System Sanitary Survey Report

SUBJECT: Richmond City
Waterworks: Richmond, City Of
PWSID: VA4760100

Survey Date: February 23, 2026

Figure 1. Electrical substation

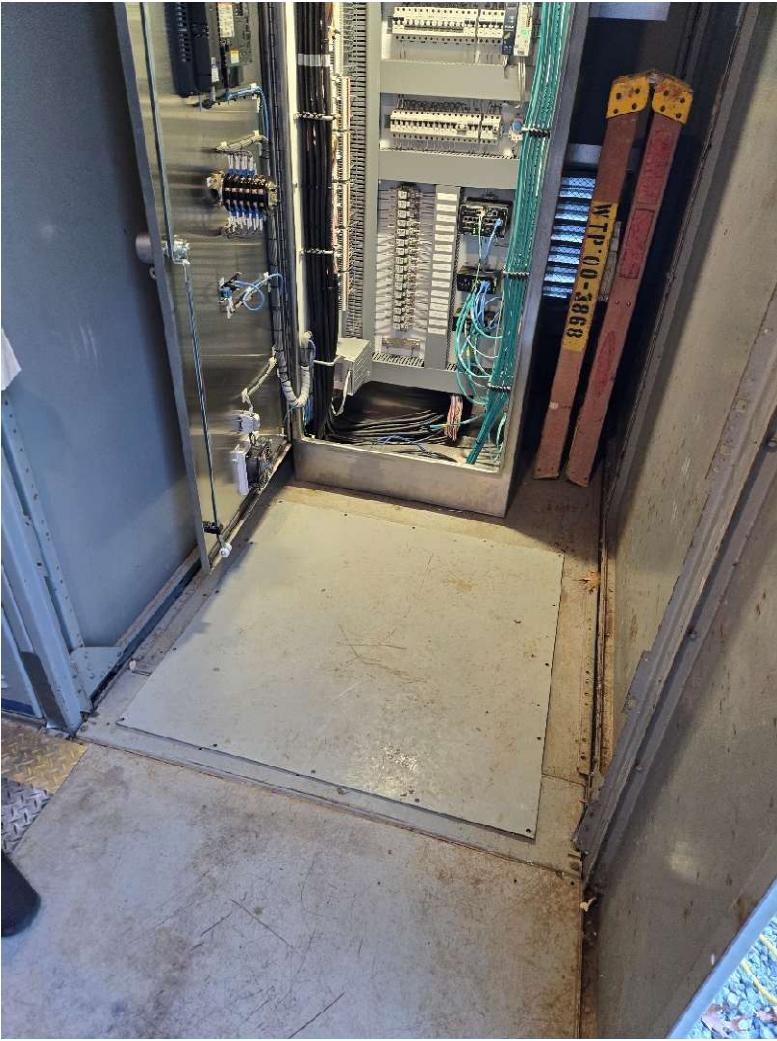
- Electrical substation project was in progress to replace/rehab the substation (Figure 1)
- Automatic transfer switch was installed to allow automatic activation of the generators should both substation feeds go down. The transfer switch was tested and worked successfully. (Figure 2)

Figure 9. Raw pump motor screen (2025 left), Screen intact, all raw water pumps checked (2026 two photos on right)

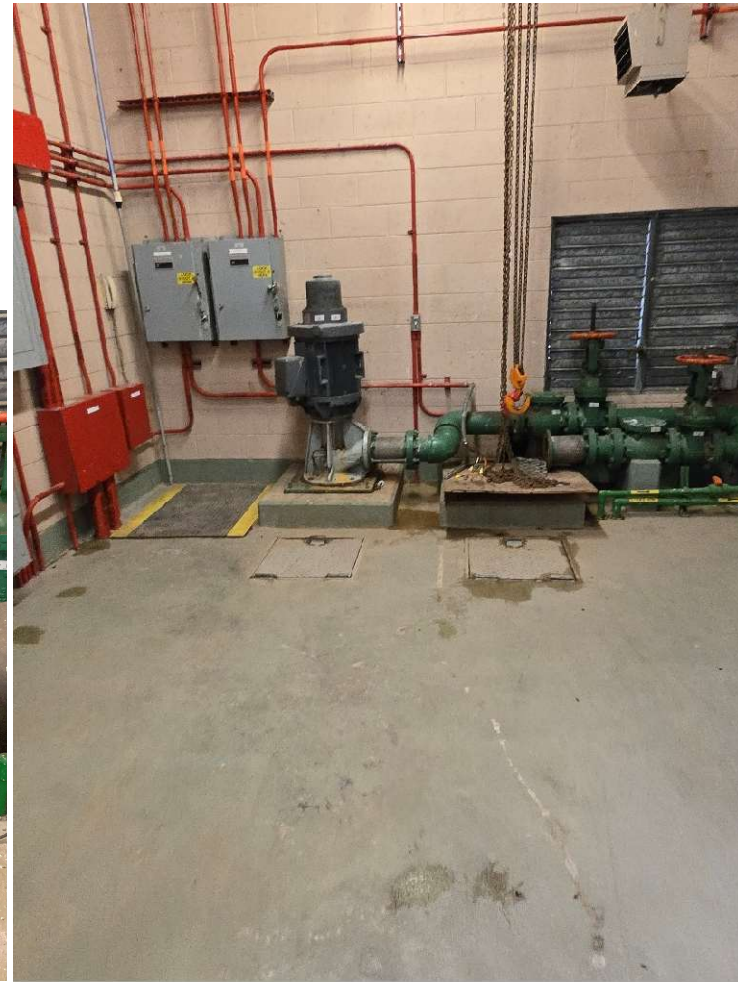
| Observation Number | Facility Inspected | 2025 VDH ODW Observation | 2026 VDH ODW Observation | Status | Accompanying Photograph (Appendix A) |
|--------------------|--------------------|---------------------------------------------------------------------------------------------------------------------------------------------------------------------------------------------------------------------------------------------------------------------------------------------------------------------------------------------------------------------------------------------------------------------------------------------------------------------------------------------------------------------------------------------------------------------------------------------------------------------------------------------------------------------|--------------------------------------------------------------------------------------------------------------------------------------------------------|-------------------------------------------------------------------------------------------------------------------------------------------------------------------------------------------|--------------------------------------|
| VDH-16 | Raw Water Pumps | The screen that protects persons from the rotating motor shaft for Raw Water Pump 2 was dislodged and laying on the floor. This is a safety issue for personnel. The screen should be re-installed and an evaluation of potential safety hazards throughout the WTP and distribution system conducted and identified hazards remedied. | Screens observed intact | Resolved | Figure 9 |

- Raw water pump shaft safety guards all in place and intact (Figure 9)
- No bird droppings or trash observed in raw water pump buildings, all buildings clean and orderly (Figure 10)
- All pumps operable
- Permanganate being fed year round downstream of raw water pumps (Figure 11)

Figure 15. Obsolete equipment abandoned in place (2025), Wiring removed as much as possible (2026)

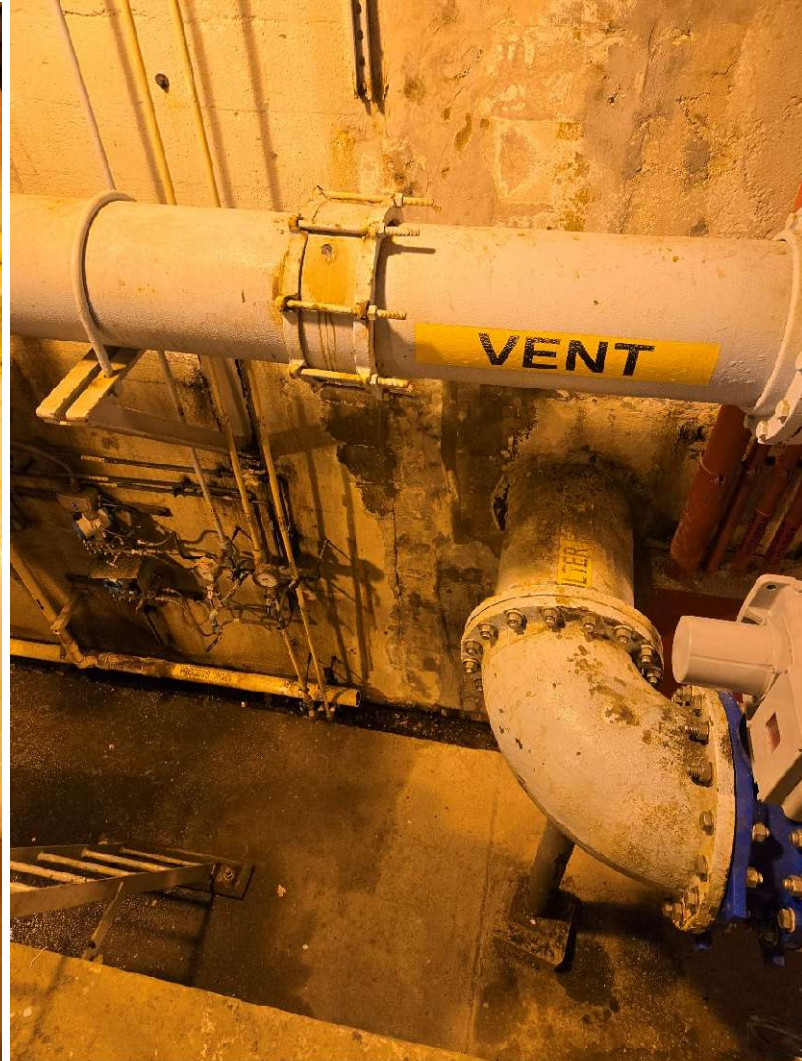
| Observation Number | Facility Inspected | 2025 VDH ODW Observation | 2026 VDH ODW Observation | Status | Accompanying Photograph (Appendix A) |
|--------------------|-----------------------------|--------------------------------------------------------------------------------------------------------------------------------------------------------------------------------------------------------------------------------------------------------|--------------------------------------------------------------------------------|----------------------------------------|--------------------------------------|
| VDH-81 | Infrastructure | In various locations at the plant and in the distribution system, old equipment that is not in use remains abandoned in place. This creates some confusion as to what is used, what is not used. Obsolete equipment should be uninstalled and removed. | Obsolete wiring and equipment has been removed where feasible | Resolved | Figure 15 |

- System has resumed filter drop tests, backwash expansion tests. Plans to incorporate routine filter rise tests in 2026.
- Some of the obsolete electrical wires and associated equipment that were previously observed in the filter gallery have been removed as much as feasible and cleaned up (Figure 15)

Figure 19. Backwash waste area (2025); (2026)

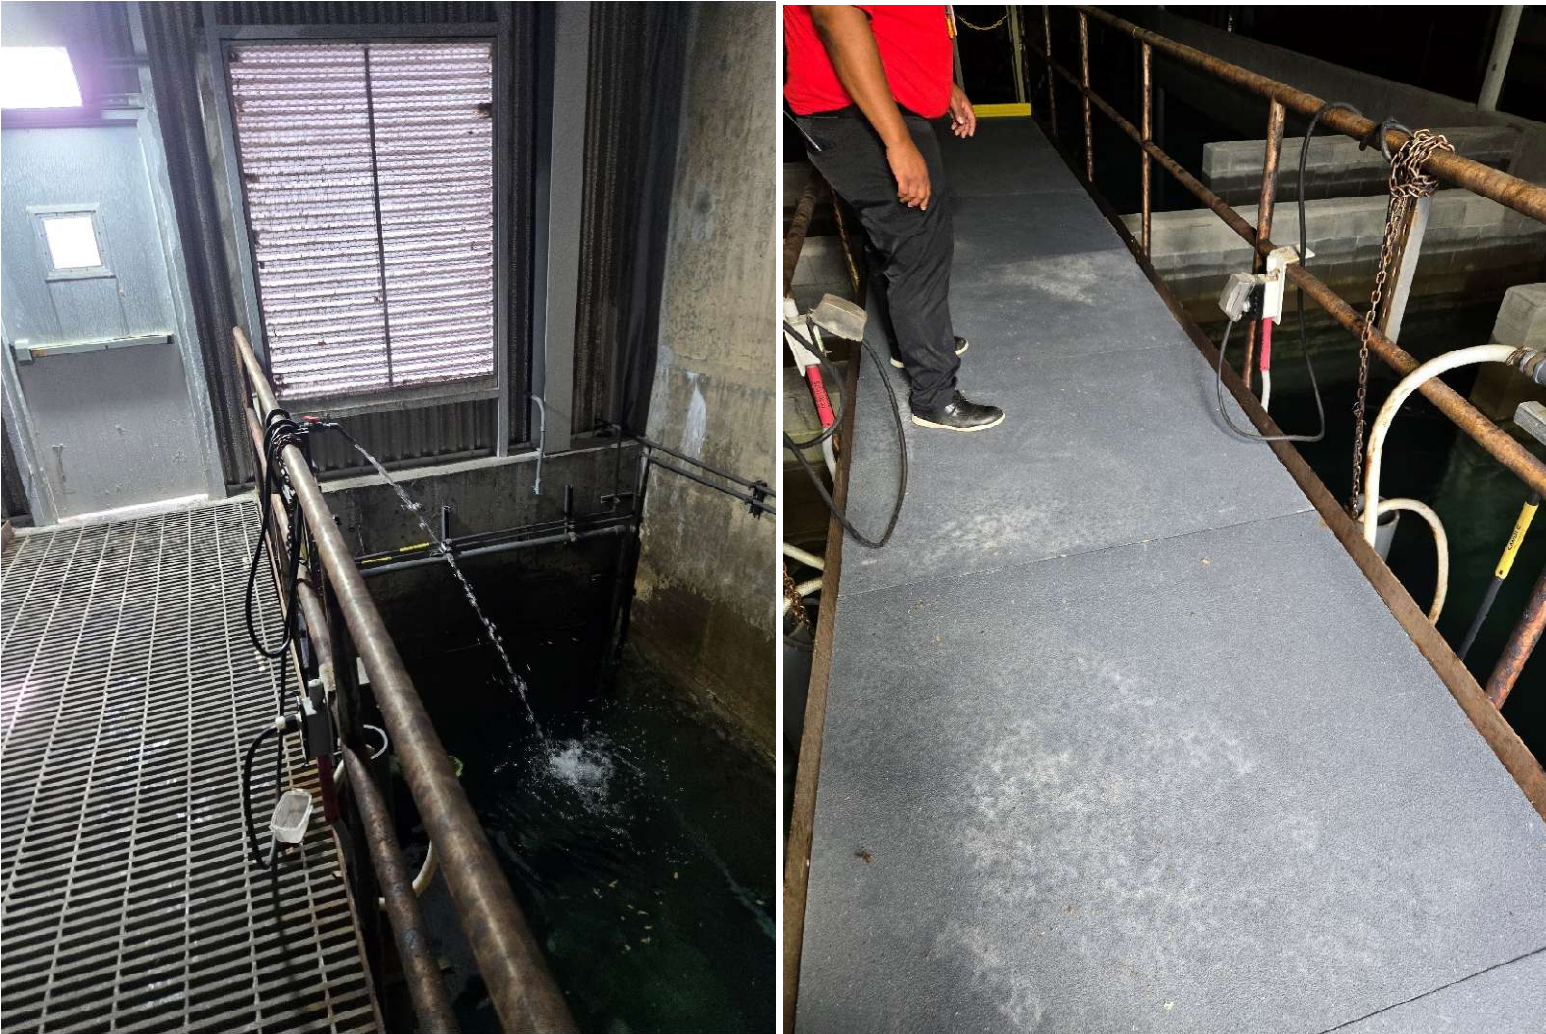
| Observation Number | Facility Inspected | 2025 VDH ODW Observation | 2026 VDH ODW Observation | Status | Accompanying Photograph (Appendix A) |
|--------------------|----------------------|------------------------------------------------------------------------------------------------------------------------------------------------------------------------------------------------------------------------------------------------------------------------------------------------------------------------------------------------------------------------------------------------------------------------------------------------------------------|------------------------------------------------------------------------------------------------------------------------------------------------------------------------------------------------------|----------|--------------------------------------|
| VDH-02 | Plant 1 Filters | Filter No. 6 appeared to have an active leak through the concrete in the filter pipe gallery. Prolonged leaking could potentially compromise the concrete and result in failure of the filter. | Concrete repair completed, no active leak observed. | Resolved | Figure 16 |
| VDH-03 | Plant 1 Filters | There appeared to be an active leak in the pipe gallery that appeared to have either biological growth or just appeared slimy. The leak should be investigated. | Concrete repair completed, no active leak or biological growth observed | Resolved | Figure 17 |

- No active leaks or biological growth observed (Figure 16, Figure 17)
- Backwash waste area appeared to have less standing water (Figure 19)

Figure 20. Water beneath grates visible, no solid base on walkway (2025); Grates covered (2026)

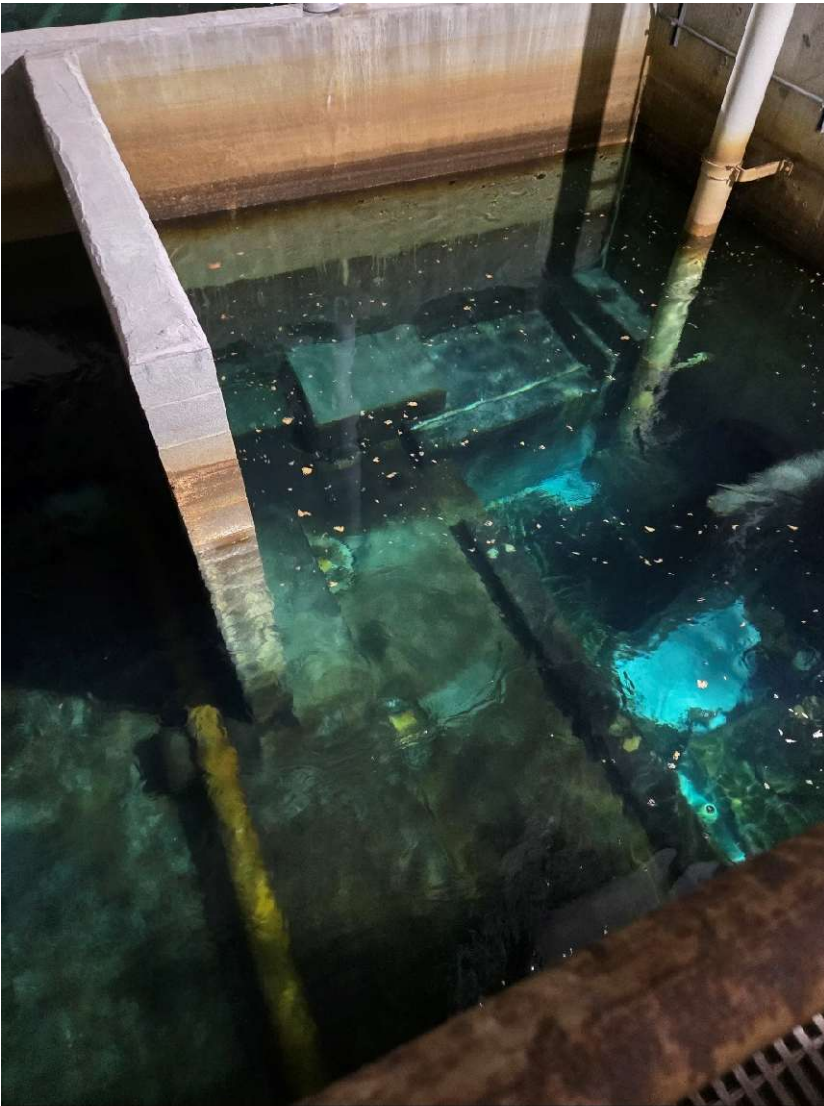
| Observation Number | Facility Inspected | 2025 VDH ODW Observation | 2026 VDH ODW Observation | Status | Accompanying Photograph (Appendix A) |
|--------------------|---------------------------|----------------------------------------------------------------------------------------------------------------------------------------------------------------------------------------------------------------------------------------------------------------------------------------------------------------------------------------------------------------------|-------------------------------------------------------------------------------------------------------------------------------------------------------------------------------------------------------|----------|--------------------------------------|
| VDH-07 | Finished Water Basin | The walkway on Plant 2 at the end of the basin did not appear to have a solid base beneath the grating, allowing dirt to fall directly into the finished water from shoes, etc. A solid base should be installed beneath the grating. Scum was observed in the water at the end of the aeration basins. The source of the scum should be investigated and addressed. | Solid base observed, scum was not observed. Basins now on a cleaning frequency | Resolved | Figure 20 Figure 21 |

| Observation Number | Facility Inspected | 2022 EPA Observation | 2026 VDH ODW Observation | Status | Accompanying Photograph (Appendix A) |
|--------------------|-----------------------|----------------------------------------------------------------------------------------------------------------------------------------------------------------------------------------------------------------------------------------------------------------------------------------------------------------------------------|-----------------------------------------------------------------------------------------------------------------------------------------------------------------------------------------|----------|--------------------------------------|
| AOC-23 | Finished Water Basins | Debris collected at the door base and was easily tracked inside, and the landing area had dirt and debris and portions without a baseboard or other barrier to prevent it from falling into the finished water basin. | Baseboards installed and intact, no debris observed at door | Resolved | Figure 20 |

- All walkways into finish water basins have curbing, solid walkways to prevent dirt from falling into water (Figure 20)
- Walkways appeared clean with no debris observed (Figure 20)
- No scum observed at end of basins (Figure 21)
- System instituted routine cleaning of basins
- Previously observed obsolete PVC lines have been removed (Figure 22)
- Finish water basin lighting appears to have improved, brighter inside basins

Figure 31. Valve vault in Distribution System

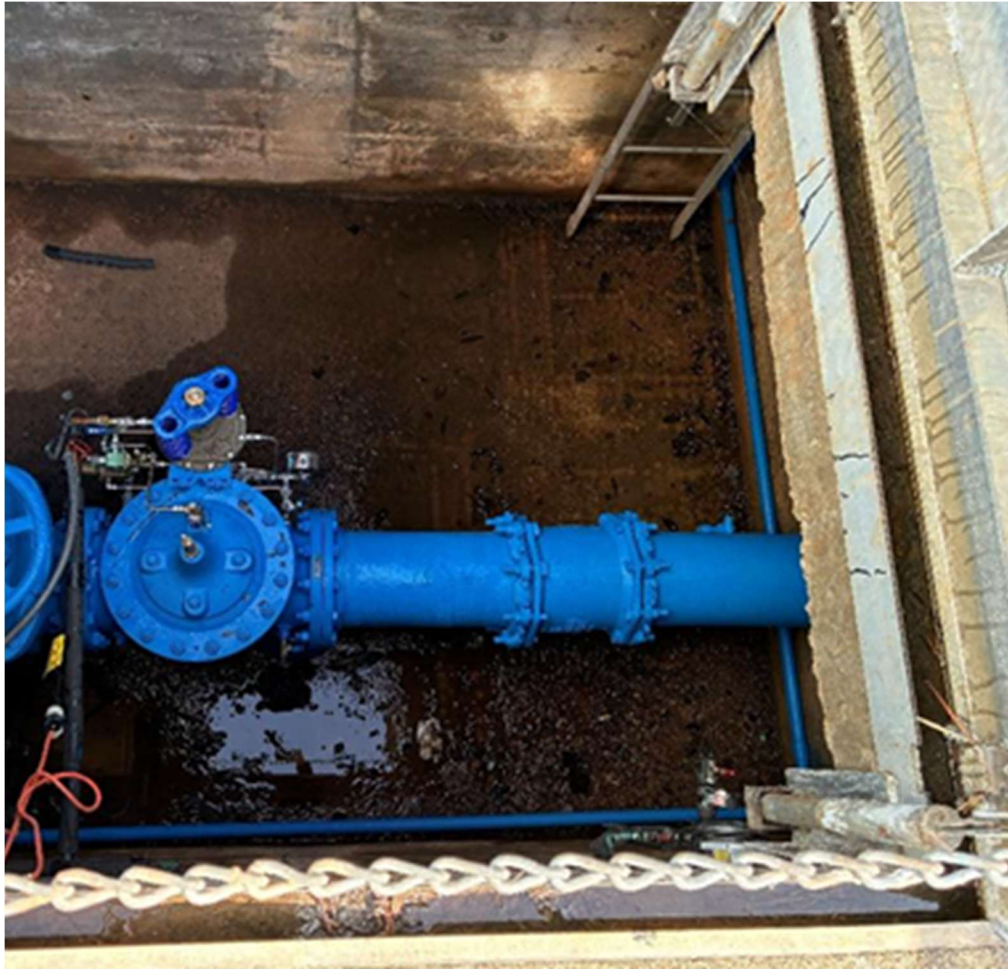
| Observation Number | Facility Inspected | 2025 VDH ODW Observation | 2026 VDH ODW Observation | Status | Accompanying Photograph (Appendix A) |
|--------------------|-------------------------------------------------|----------------------------------------------------------------------------------------------------------------------------------------------------------------------------------------------------------------------------------------------------------------------------------------|---------------------------------------------------------------------------------------------------------------------------------------------------------------------------------------------------------------------------------------|------------------------------------------------------------------------------------------|--------------------------------------|
| VDH-77 | Valve Vaults | Valves and piping in valve vaults in the distribution system including Woodside Road, Jahnke Road, and Huguenot Road tanks are heavily corroded and show signs of being submerged in water. Valve vaults should be kept dry and equipment re-coated to slow down additional corrosion. | Valve vaults appeared relatively dry at time of visit (recent waterline did not appear to show submergence of piping), piping appeared to be re-painted. System indicates all sump pumps have been replaced and verified operational | Resolved | Figure 31 |
